service bulletin

No. 98-14

Official Notification Federal Boat Safety Act Upper Motor Mount Replacement - 9.9/15 (4-Stroke)

a - Black Dot Sticker

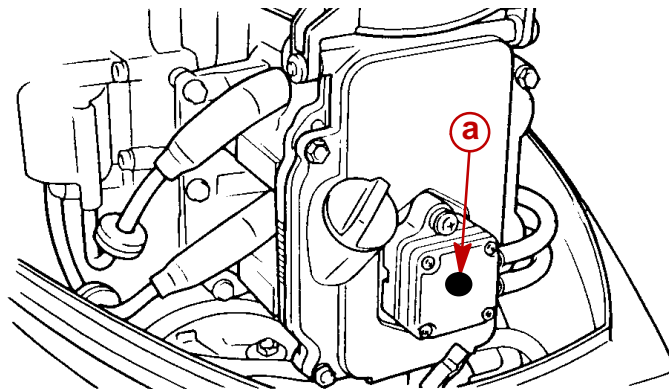
Outboards within the serial number range listed that have been reworked at the factory are identified by:

- A black dot sticker applied on the outboard serial number label of the shipping carton.
- A black dot sticker applied on the fuel pump cover.
- Use MIDAS - Product History, to determine if this fix campaign 1998-014 is "OPEN" or has been "COMPLETED".

Part Identification

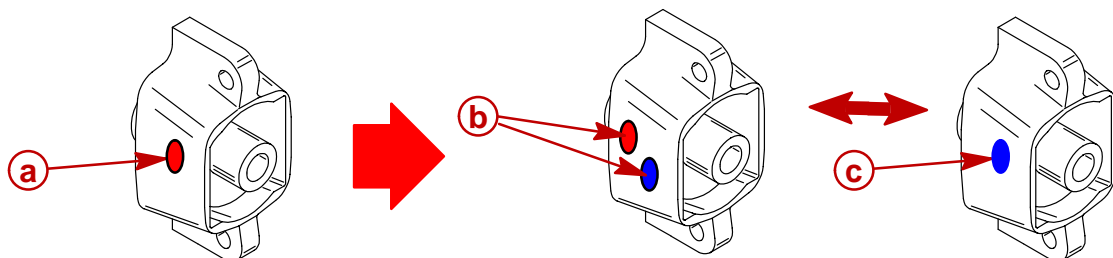
The new replacement upper motor mounts are identified by both a blue and a red or a single blue paint dot located on the driveshaft housing side of each motor mount housing.

a - Mount with single red paint dot - **MUST** be replaced (p/n 835410)

b - Mount with both a red and a blue dot - good mount (p/n 835410T)

c - Mount with single blue dot - good mount (p/n 835410T)
